Access Compliance Report

Public Rights-of-Way

(Curb Ramps)

Intersection ID: 27432	Main Street: BALLANTYNE_COMMONS_PY	Cross Street: DURANT_BV	Location: NE
ADA ID: 039676BB9B31	Ramp Type: Perp	Initial Pass/Fail: Fail	Overall Compliance: No
Severity Score: 37.5			
Codes/Mitigation Info/Possible Solution		Field Measurements/Component Compliance

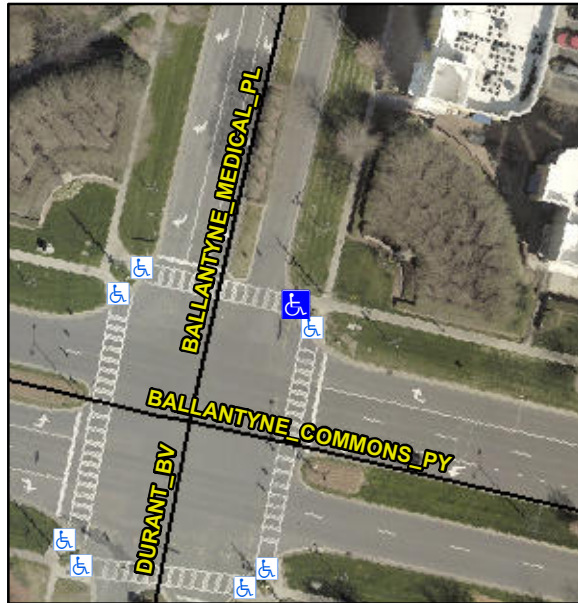
Not Found, R304.2.2, R304.5.3

Compliance	Description	Data	Compliance	Description	Data
N/A	Ramp Length (in)	128.0	No	Ramp Slope (%)	10.4
Yes	Ramp Width (in)	48.0	No	Ramp XSlope (%)	12.4
N/A	Flare Type LT	N/A	N/A	Flare Type RT	N/A
N/A	Flare Slope LT (%)	N/A	N/A	Flare Slope RT (%)	N/A
N/A	Flare Traversable LT?	N/A	N/A	Flare Traversable RT?	N/A
N/A	Landing Length (in)	N/A	N/A	DWS Provided?	N/A
N/A	Landing Width (in)	N/A	N/A	DWS Contrast?	N/A
N/A	Landing Slope (%)	N/A	N/A	DWS Length (in)	N/A
N/A	Landing X Slope (%)	N/A	N/A	DWS Full Width?	N/A
N/A	Landing Curb? (Y/N)	N/A	N/A	DWS Offset (in)	N/A
N/A	Shared Landing?	N/A			
N/A	Gutter Ponding?	N/A	N/A	Gutter Slope (%)	N/A
N/A	Gutter Lip Ht (in)	N/A	N/A	Gutter X Slope (%)	N/A
N/A	Painted X Walk1?	Yes	N/A	Painted X Walk2?	N/A
	X Walk 1 Direction	To W		X Walk 2 Direction	N/A
N/A	X Walk 1 Width (in)	125.0	N/A	X Walk 2 Width (in)	N/A
	X Walk 1 Slope (%)	2.8		X Walk 2 Slope (%)	N/A
	X Walk 1 X Slope (%)	7.3		X Walk 2 X Slope (%)	N/A

Remove & Replace Entire Ramp.
